TITLE : FUSELAGE - FUSELAGE AFT SECTION - CHANGE FASTENER AT FR91

This page transmits Revision No. 01 of Service Bulletin No. A310-53-2126.

SERVICE BULLETIN No. : A310-53-2126

REVISION No. : 01 - May 31/07

Figure 5 Sheet 1
Config. 02: Installation of the Reinforcing Angles

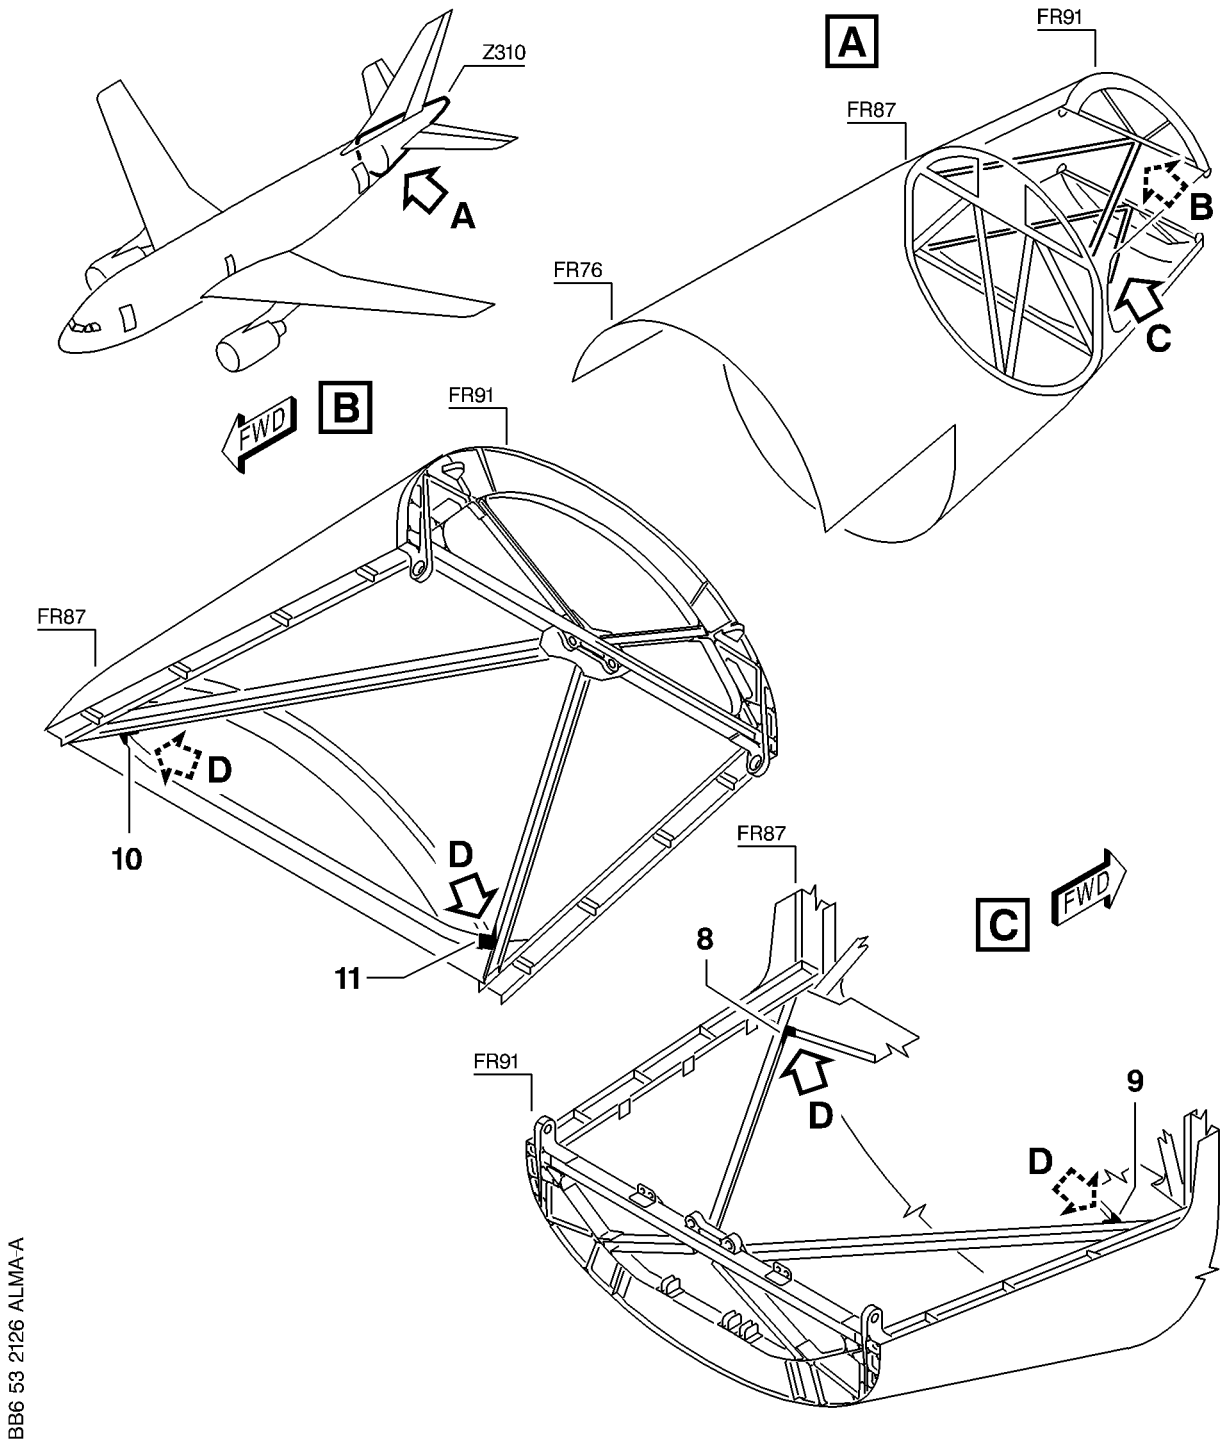
Refer to Figure 5 , Sheet 1 , Detail B.

Refer to Figure 5 , Sheet 1 , Detail C.

Figure 5 Sheet 2
Config. 02: Installation of the Reinforcing Angles

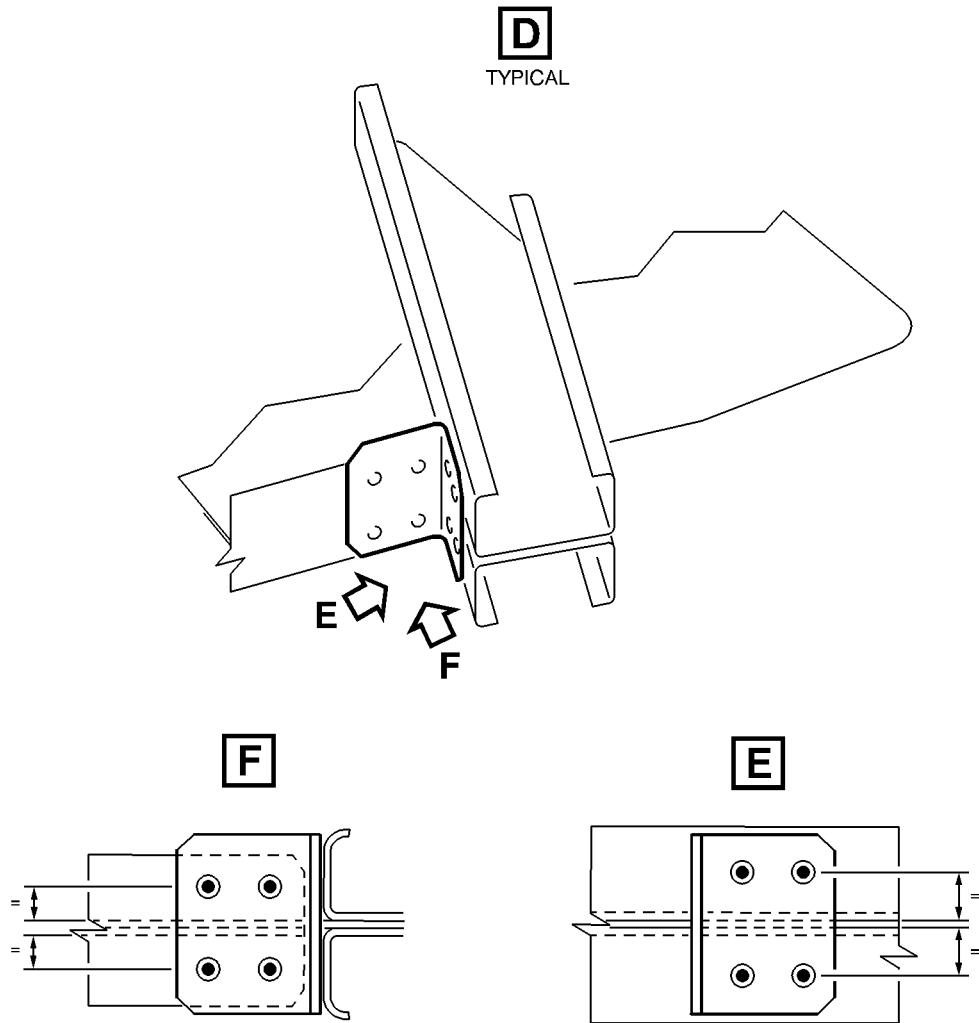
Refer to Figure 5 , Sheet 2 , Details E and F.

Refer to Figure 5 , Sheet 2 , Details E and F.
